REPORT

South End Pool & Aquatic Equipment/ Systems Improvement Analysis and Recommendations

May 19, 2017

CHA Project No: 32892

PHOTO No: 9	
LOCATION: Exterior of Concrete wall - Filter room	
DESCRIPTION: Deteriorated rubber seal at pipe penetration through concrete wall. Water leaking through joint.	
PHOTO No: 10	
LOCATION: Swimming pool concrete floor (Slab-on-grade)

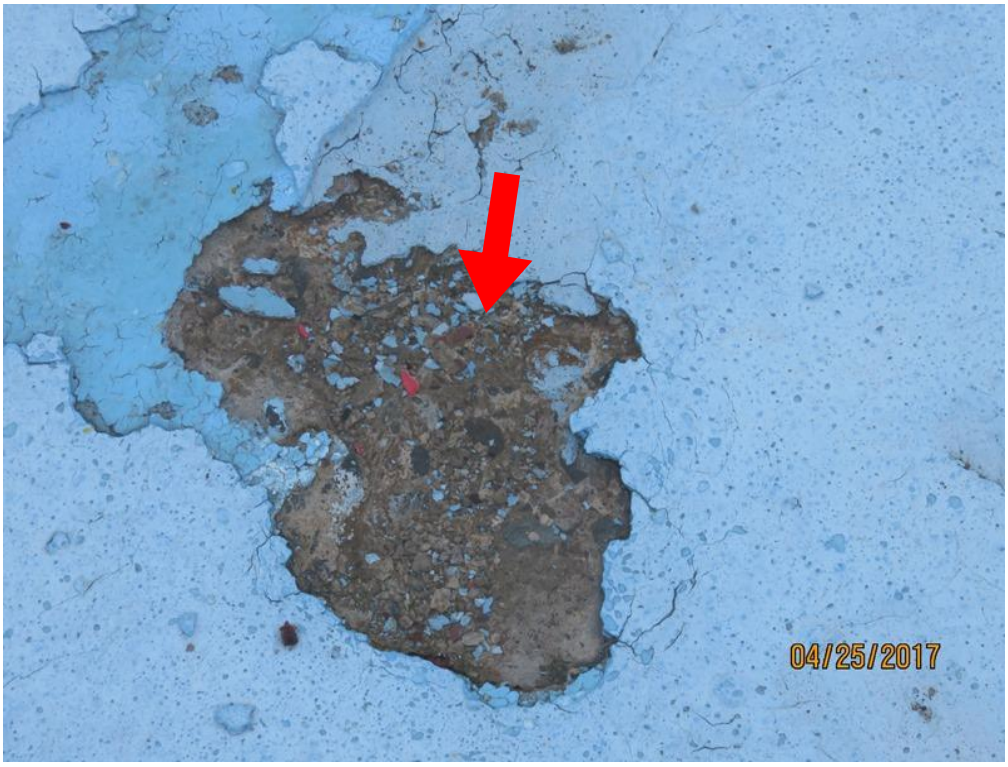
e) At several locations, we observed areas of deteriorated epoxy coating (waterproofing) on the pool floor and walls (*See Appendix B, Photograph Nos: 10 and 11*).

6. The interior of all pool walls and floor should be epoxy painted or waterproofed.
7. All pipe penetrations through the pool walls should be replaced.
